# LONG WALL

# 253 LEAM ROAD

# DEVELOPMENT APPLICATION

REQUEST FOR FURTHER INFORMATION

<b>Drawing Title:</b> DRIVEWAY PROFILE		<b>Issue:</b>
<b>Scale:</b> 1:200	<b>Drawing No:</b>	RFI.02
<b>Date:</b> 19/04/2024		
<b>Drawn by:</b> JP		
<b>Checked by:</b> TB		
<b>Status:</b> DA

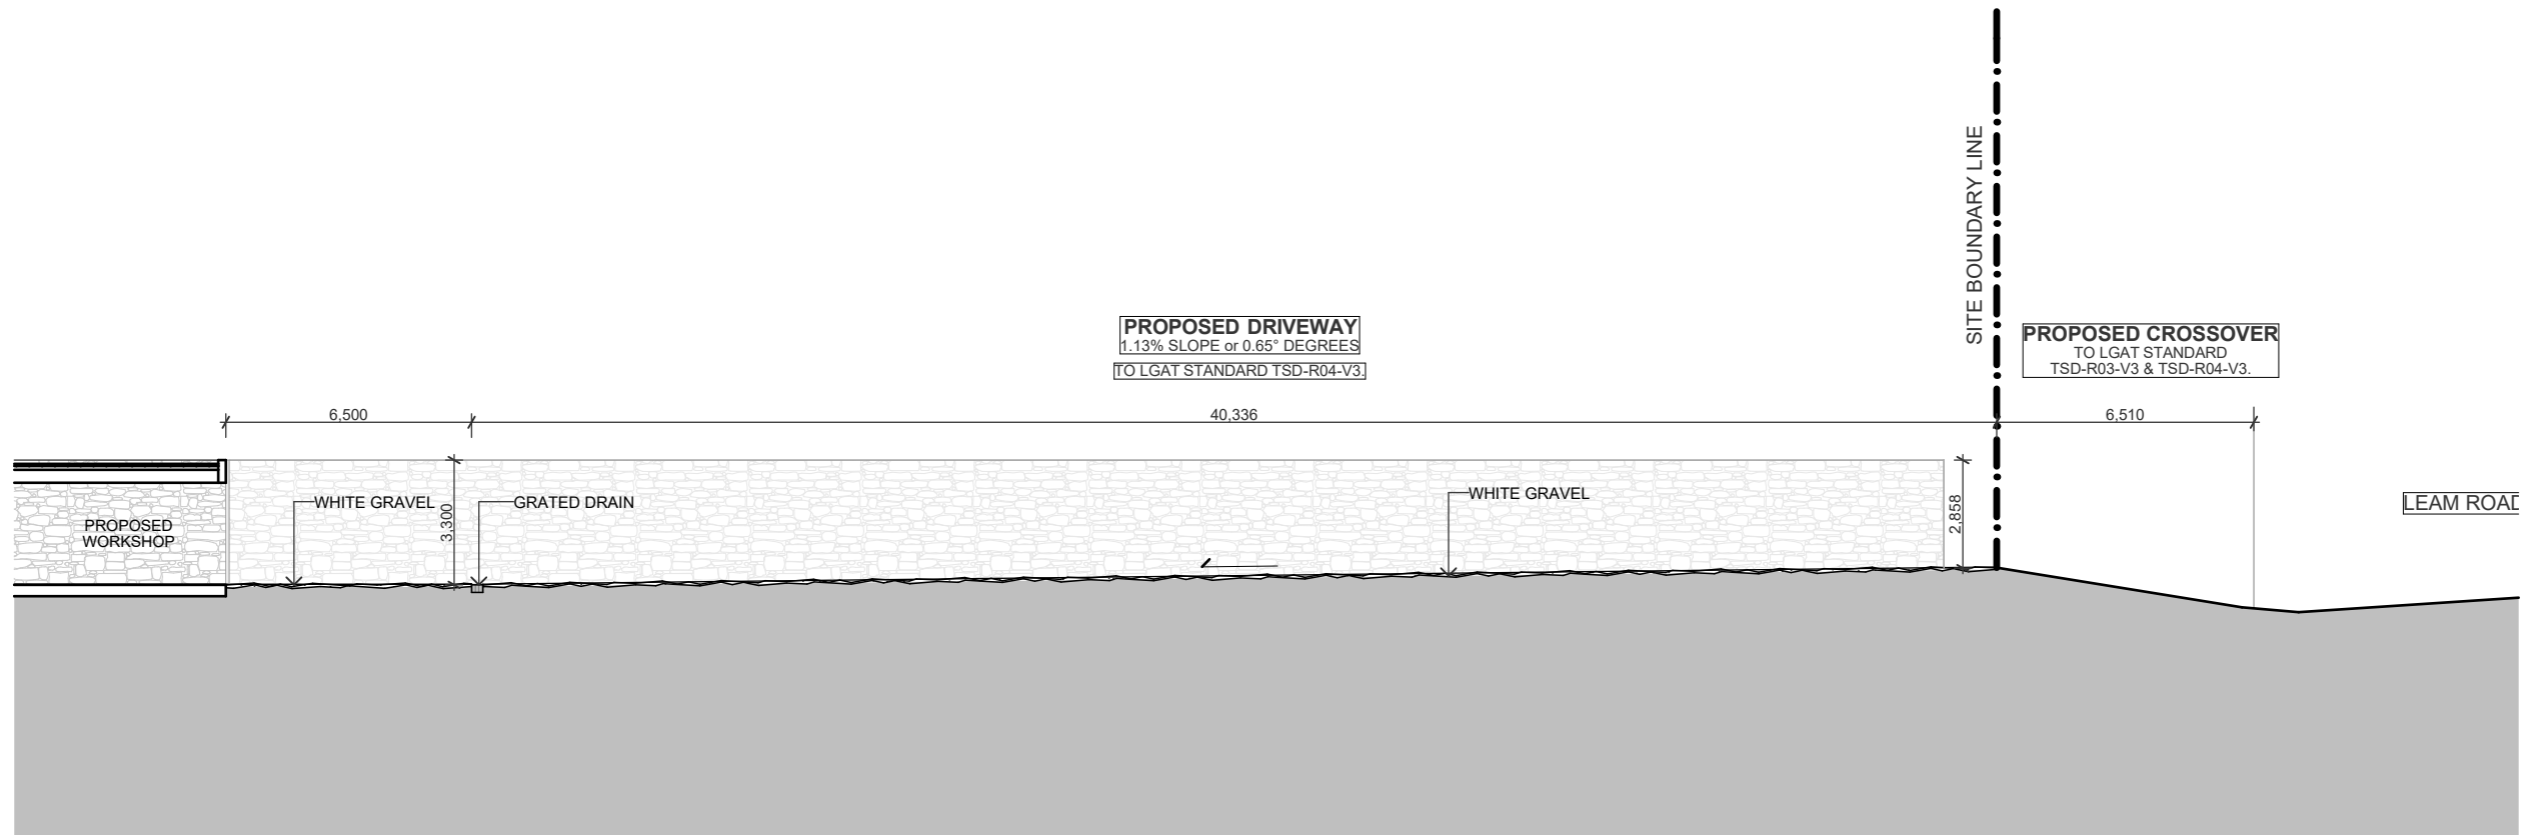
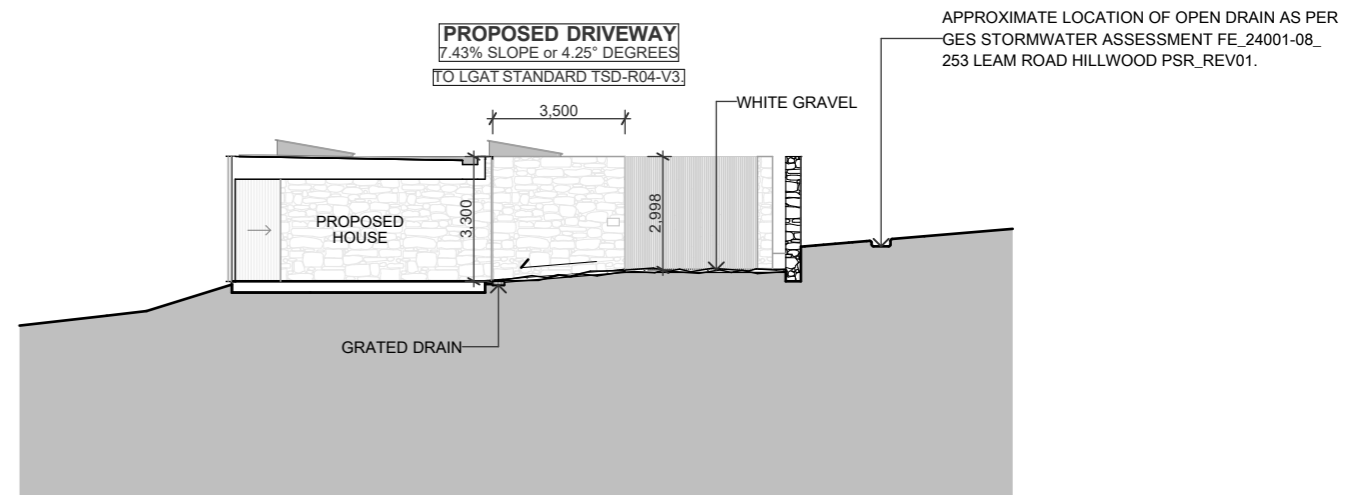
For further clarification, the proposed driveways have grated drains at the lowest point to direct concentrated stormwater toward DP/stormwater storage tank located in the revised stormwater report. These locations are marked on the drawing RFI.02, provided as a part of the revised architectural set dated 19.04.2024.

The proposed driveway's profile is shown on the drawing RFI.02, provided as a part of the revised architectural set. As can be seen, both driveways satisfy the typical driveway profile as per LGAT TSD-R04-v3.

Scale:	1:500	Drawing No:	<b>A0.02</b>	Issue:	<b>RFI</b>
Date:	13/03/2024	Drawn by:	JP	Checked by:	TB
Status:	DA

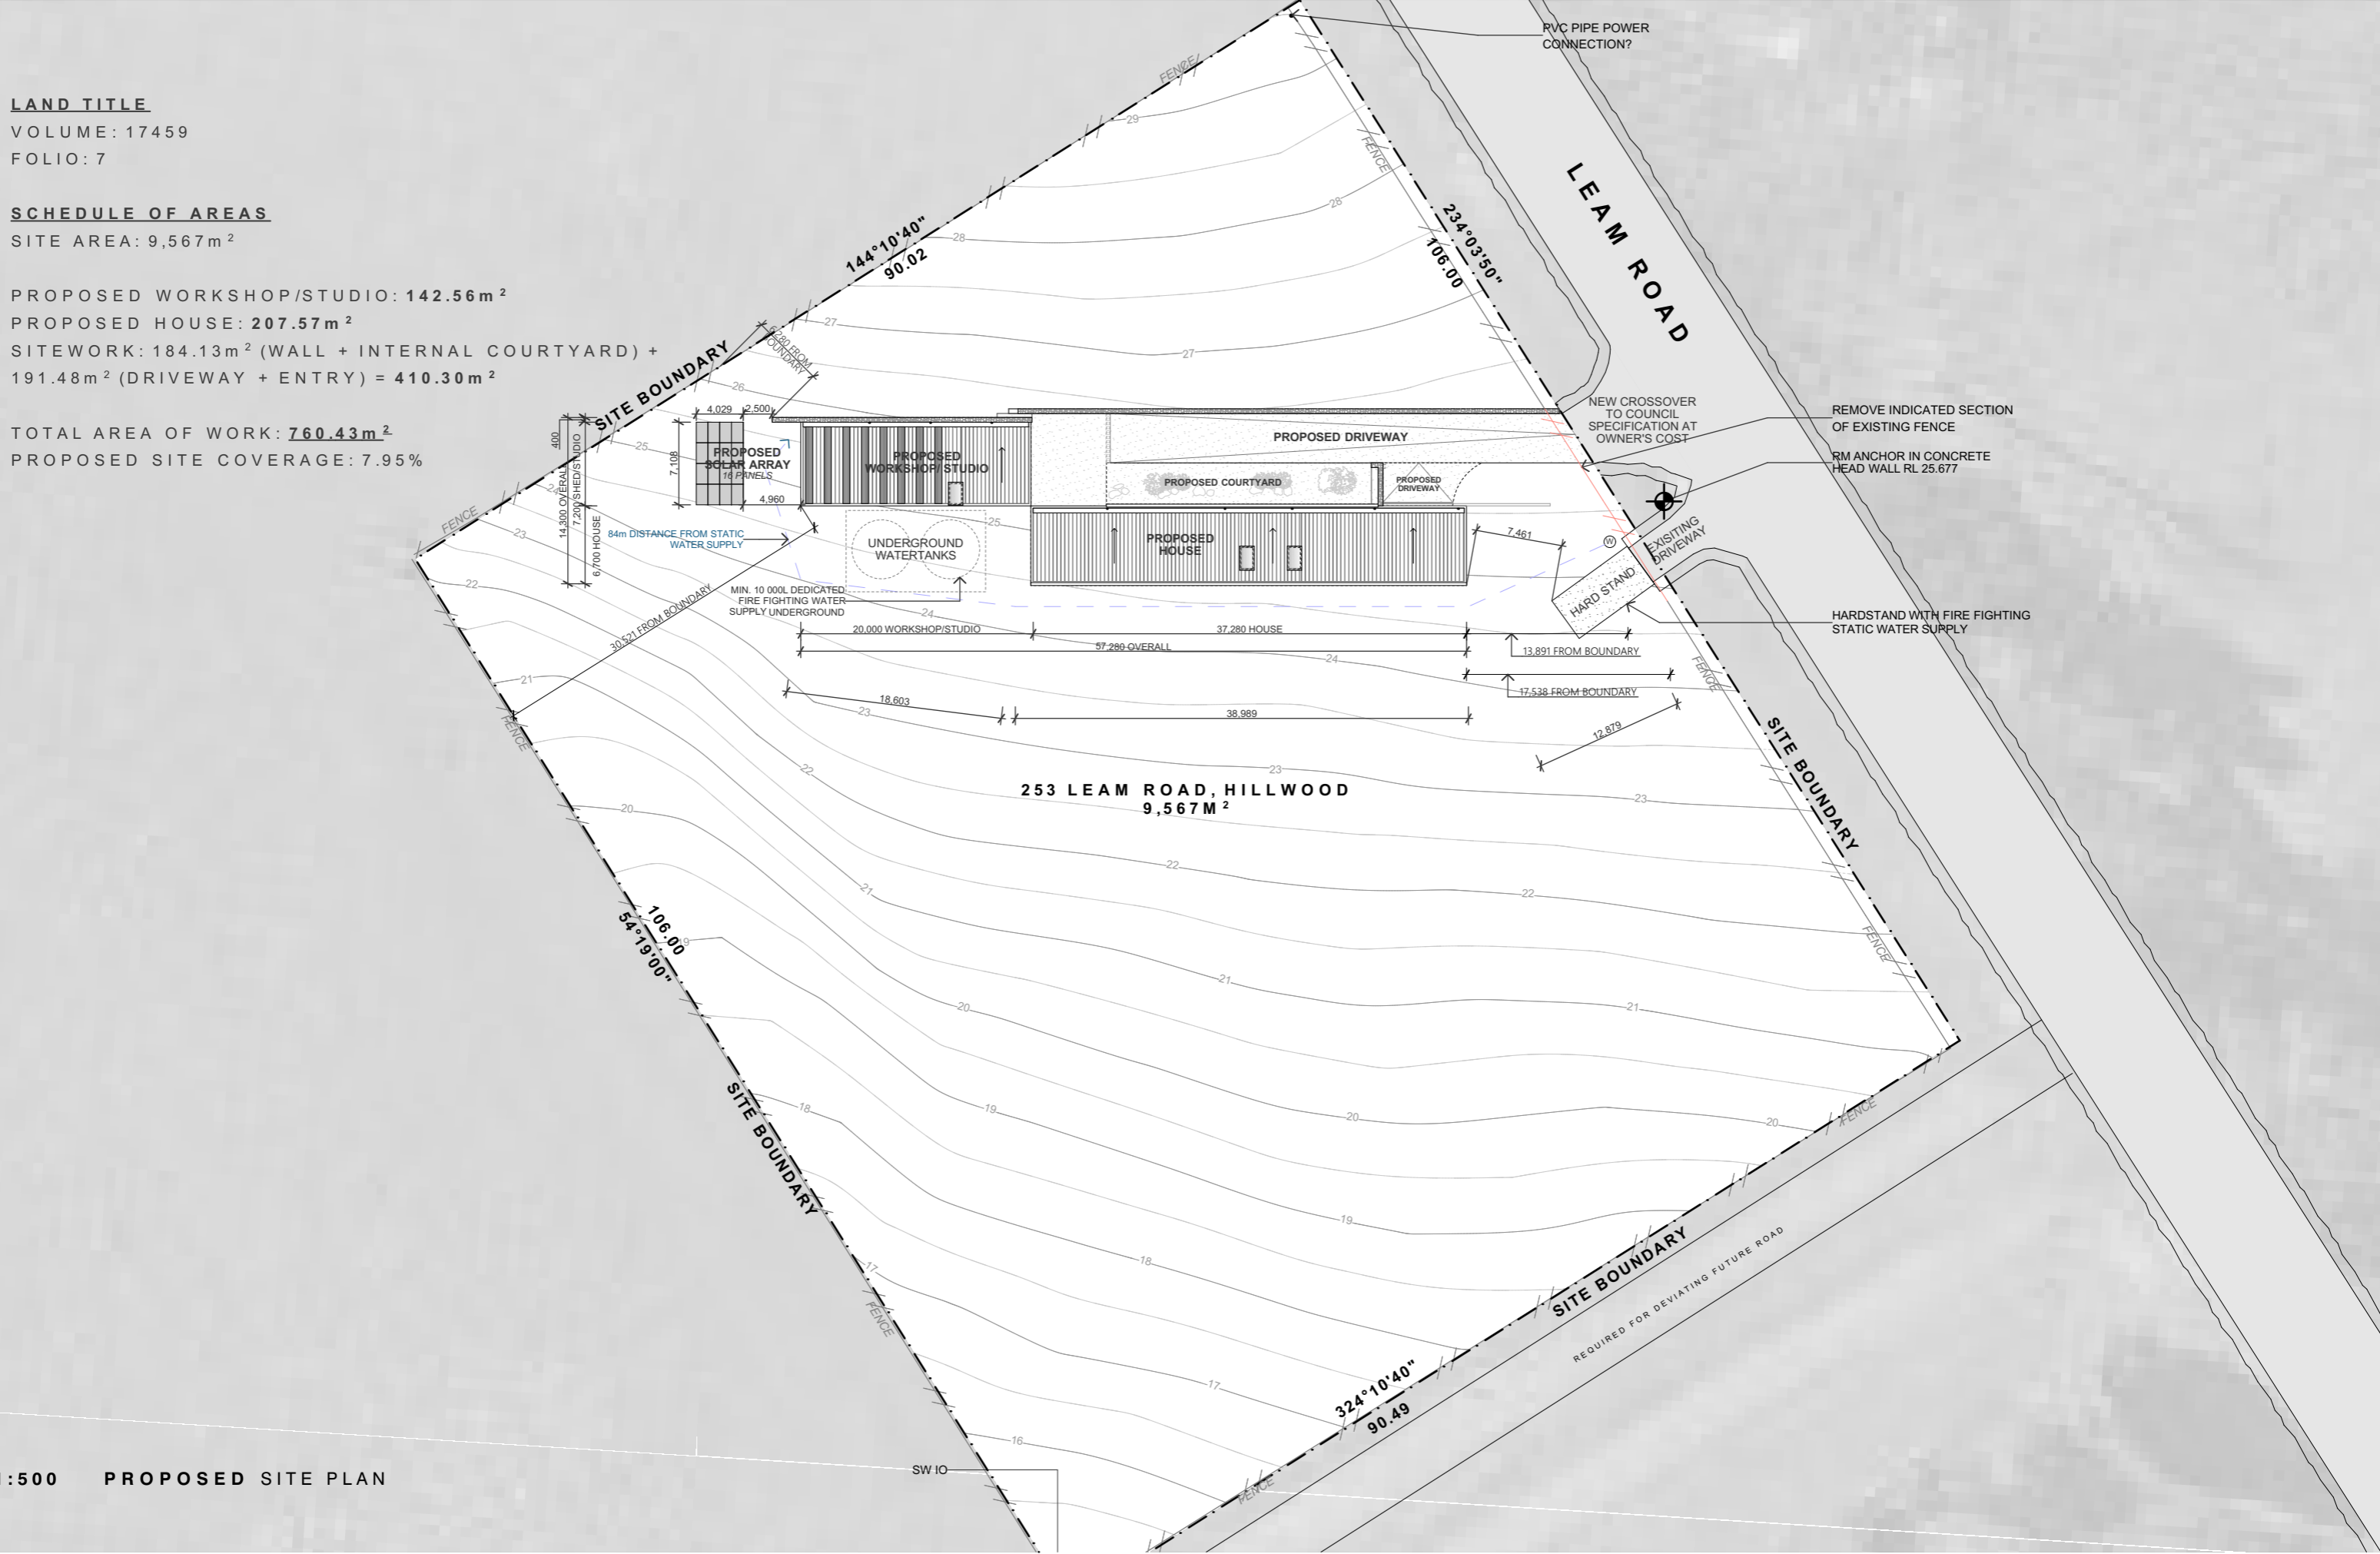
As for the driveway not being a perpendicular access from the road, our team believes that the 6.5m length of the new crossover (now marked on the revised site plan drawing #A0.02) will be sufficient for drivers to be alerted as they enter/exit. The fact 'the long wall' terminates beyond 6.5m from Leam Road is also a plus. (This item had been communicated to Georgetown Council planner, Alexander Bowles, on

The note regarding the new crossover is now revised from generic note to a detailed note specifying the exact LGAT standard clause to follow when constructed.
